2011 RADIOACTIVE EFFLUENT RELEASE REPORT
VOLUME 2

MILLSTONE POWER STATION UNITS 1, 2, AND 3
DOMINION NUCLEAR CONNECTICUT, INC. (DNC)

**Radiological Effluent Monitoring and Off-Site
Dose Calculation Manual (REMDCM)**

Rev. 026-02

Figure I.C.-3, "Simplified Liquid Effluent Flow Diagram Millstone Unit 3"

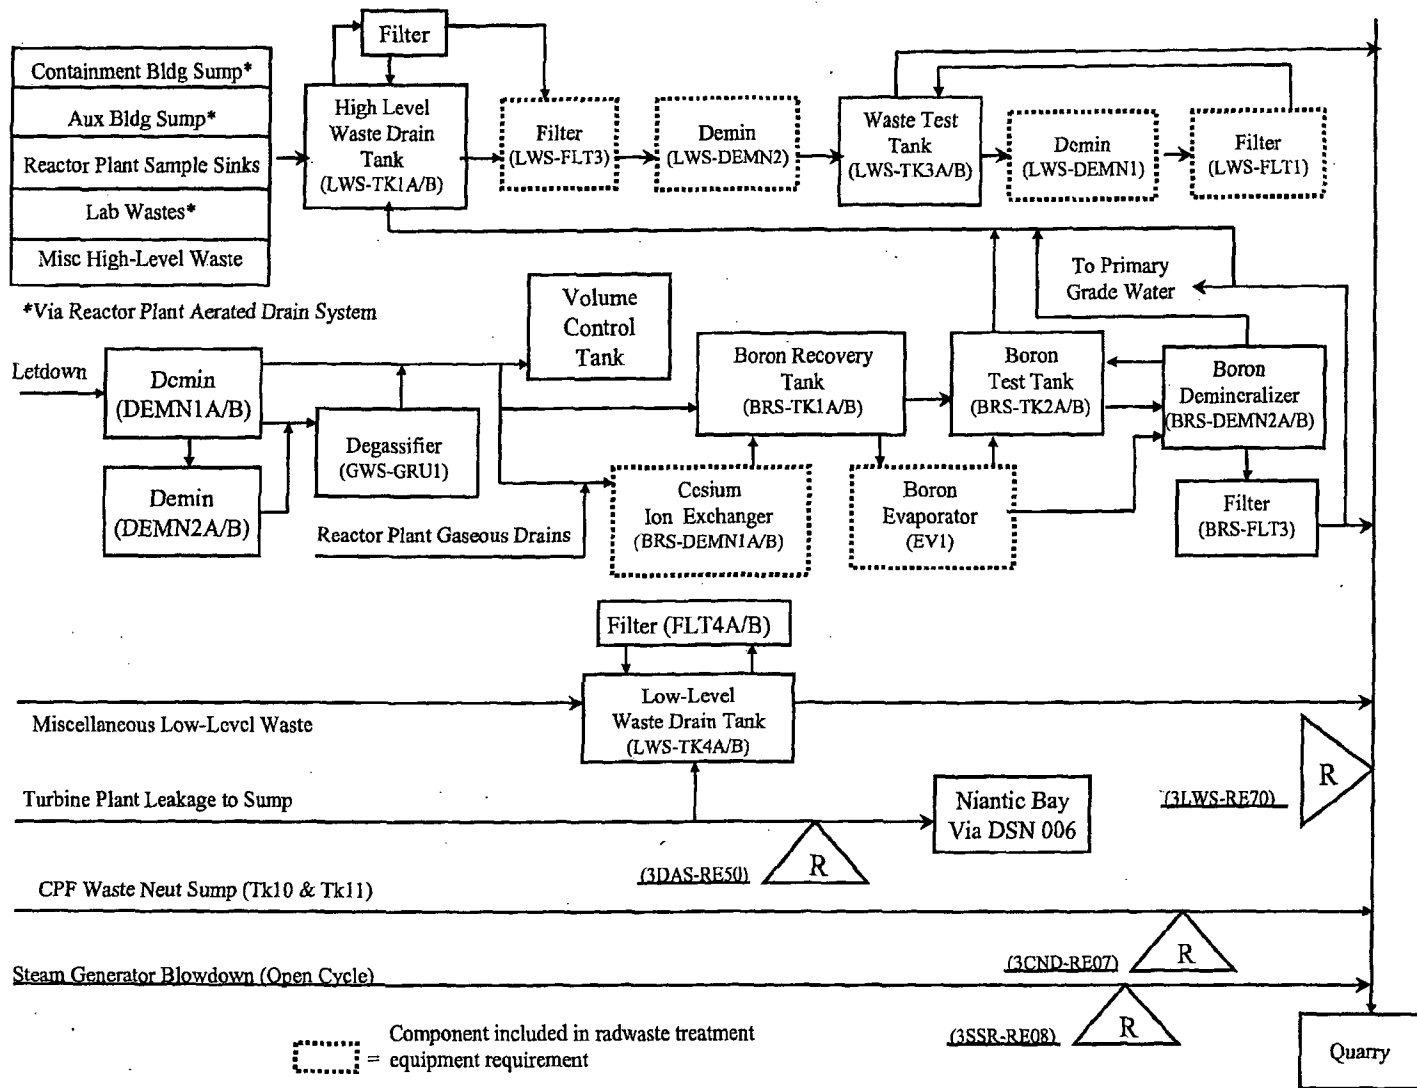
1. In table on page 18. Changed "Reactor cavity" to "Spent Fuel Pool" under Millstone Unit No. 1.
2. In Figure I.C.-3 corrected Cesium Ion Exchanger identifier to BRS-DEMN1 A/B.

Figure I.D.-2, "Simplified Gaseous Effluent Flow Diagram Millstone Unit Two"

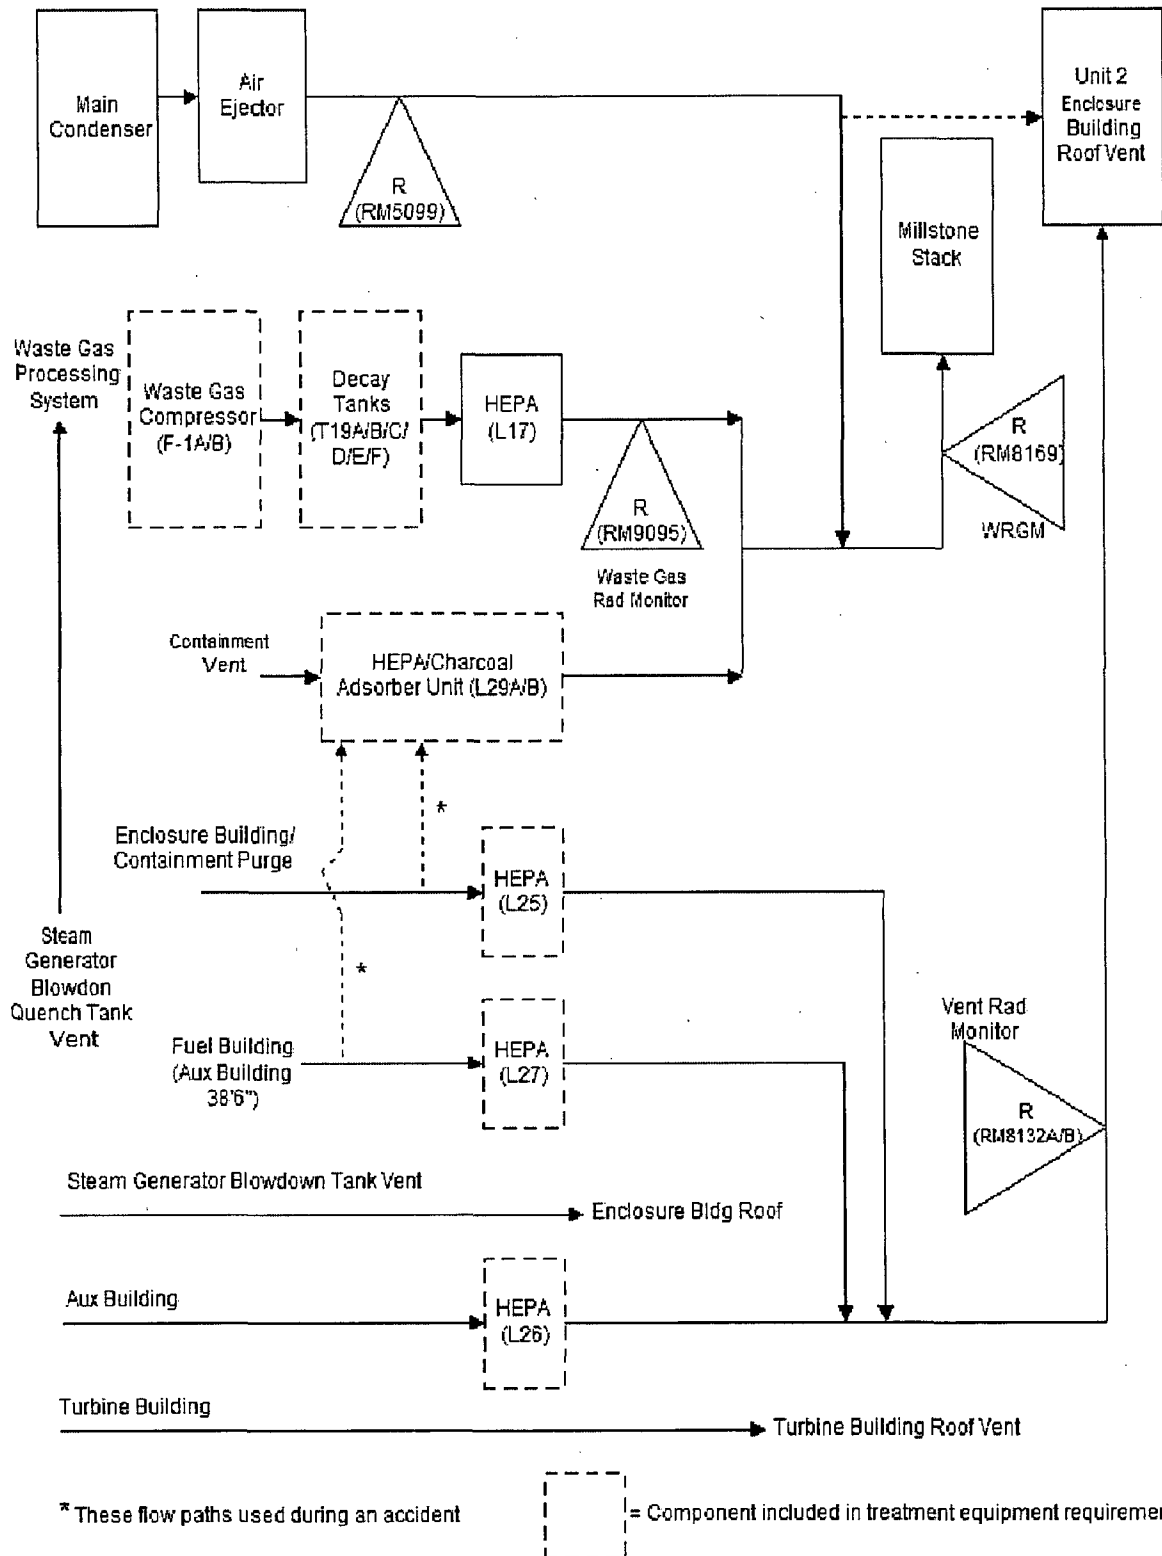
10. Figure I.D.-2 was redrawn.
11. Figure I.D.-3 was redrawn.
12. Corrected definition of LLD in Table I.E.-4 notation A. Micro was replaced with pico.
13. On page 54, in Section II.C. Liquid Dose Calculations, the sentence "Method 2 may be used in lieu of Method 1." was added to paragraph one.

Figure I.E.-1, "Inner Air Particulate And Vegetation Monitoring Stations"

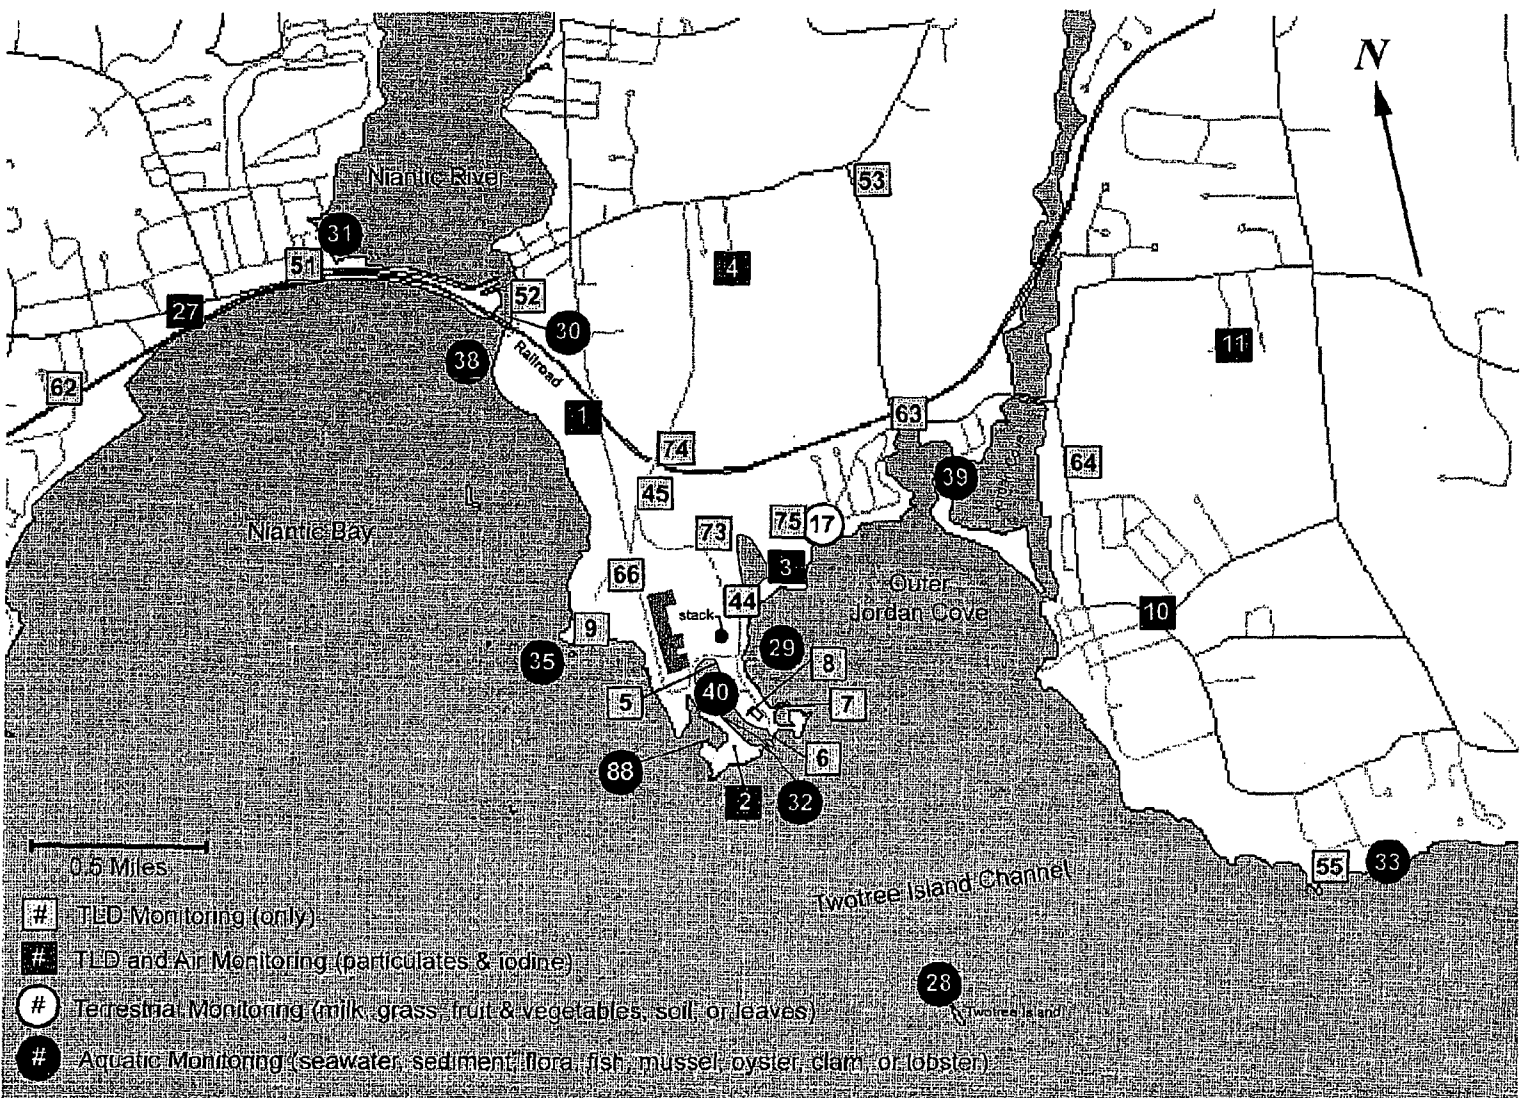
8. Revised Figure 1.E. –1, “Inner Air Particulate And Vegetation Monitoring Stations.”
9. Revised Figure 1.E. –2, “Outer Terrestrial Monitoring Stations.”
